Sydney Metro West – Westmead - Telstra and Jemena Utility Relocations

Heavy Vehicle use of Local Roads (HVLR) Application

Document Number 4271-SMW-HVLR-002
VERSION 02

DOCUMENT NO.	TITLE	VER	STATUS	NO.	DATE	COMPANY	RAISED BY	REVIEW DOC. NO.*	DOCUMENT REF*	DEED REF*	COMMENTS / RESPONSE	COMMENT CATEGORY*	CLOSED OUT
SMWSDDS-QWY-WMD-TF-PLN-000354	Westmead Heavy Vehicle Local Roads Use	A.01	RVW	01	21/09/2023	TFN	LWILBY	SMWSDDS-QWY-WMD-TF-PLN-000354	4.5 Cyclists	NA	The second sentence refers to cyclists 14 years and under, the road rule has been changed. Please update to align with this change - "children under 16 years old due to the proximity of"	Observation	N
					5/10/2023	QWAY	LCASEY	SMWSDDS-QWY-WMD-TF-PLN-000354	4.5 Cyclists	NA	Noted. Section 4.5 (second sentence) updated to reflect the change in road rules as advised.	Observation	N
				02	21/09/2023	TFN	LWILBY	SMWSDDS-QWY-WMD-TF-PLN-000354	4.5 Cyclists	NA	The second dot point currently refers to minimising or eliminating movements outside of school peak periods. Please reword so it captures the intention of minimising or eliminating movements during school peak periods. Thanks.	Observation	N

PLAN REF NO:	SP - 11	9m Rigid Truck
ROAD NAME:	BAILEY STREET	Length: 9.00 m
CROSS ST/RD:	HASSALL STREET	Max width: 2.55 m
SUBURB:	WESTMEAD	Lock to lock time: 6.0 s
OPERATION:	9M RV - RIGHT TURN	Max steering angle: 44.14°
		Turn radius (curb to curb): 9.50 m
		Turn radius (wall to wall): 10.47 m

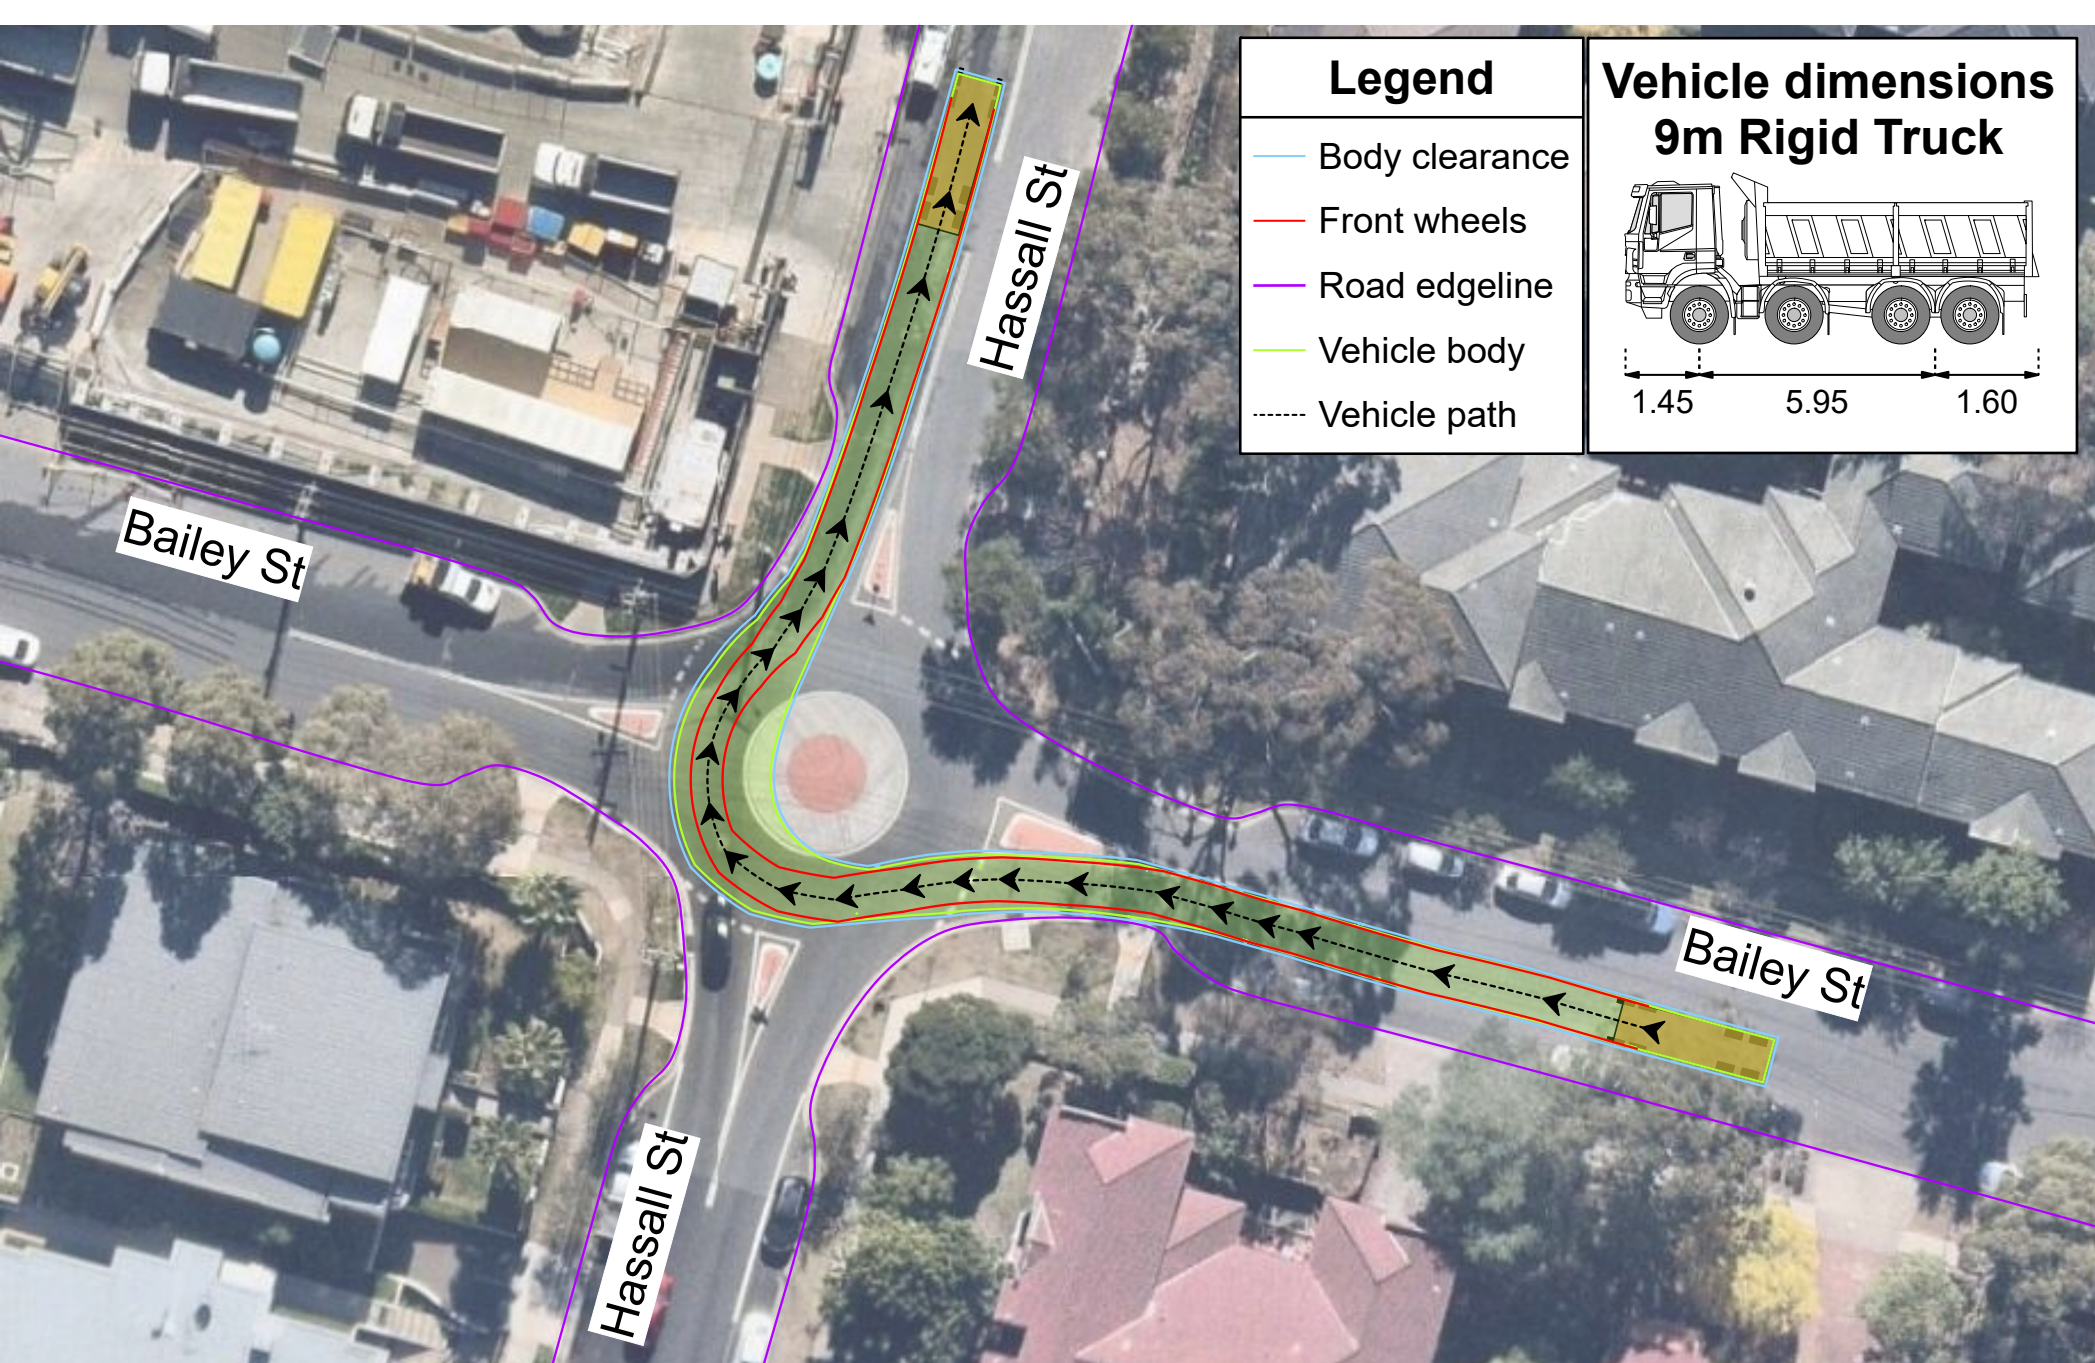
07	26/09/2023	SCO	DCROWLY	SMWSDDS-QWY-WMD-TF-PLN-000354	Appendix C – SP-11	-	Swept path has a 9m Rigid driving across the roundabout. Is the roundabout to be removed?	Observation	N
					7/10/2023	QWAY	LCASEY	SMWSDDS-QWY-WMD-TF-PLN-000354	Appendix C – SP-11	-	The roundabout removal is outside of Quickways scope. This is in GLC's scope of works. Quickway have planned the Project based off the existing road configurations/conditions at the time of development.	Observation	N
				08	26/09/2023	SCO	DCROWLY	SMWSDDS-QWY-WMD-TF-PLN-000354	General Comment	-	All heavy vehicles should utilise the signalised intersection at Hawksbury Rd and Priddle St as opposed to making a right turn in and a right turn out movement at the intersection of Hawksbury Rd and Bailey St.	Observation	N
					7/10/2023	QWAY	LCASEY	SMWSDDS-QWY-WMD-TF-PLN-000354	General Comment	-	Noted. HV egress can be prioritised to exit via left turn only from Hawksbury Rd onto Bailey Street or to egress via the Priddle Street and Hawksbury Rd signalised intersection. HV access, however, for 12.5m HV's will need to occur from Hawksbury Rd right into Bailey Street. This is required beacuse 12.5m HV's cannot make the left turn from Priddle Street into Hassall Street due to existing median islands. (Refer for SP-13 in Appendix C). 9m HV's and smaller will be advised to use the Priddle St and Hawksbury Rd signalised Intersection as a priority. Quickway notes that the 12.5m inbound HV movements will only occur approximately twice per shift.	Observation	N
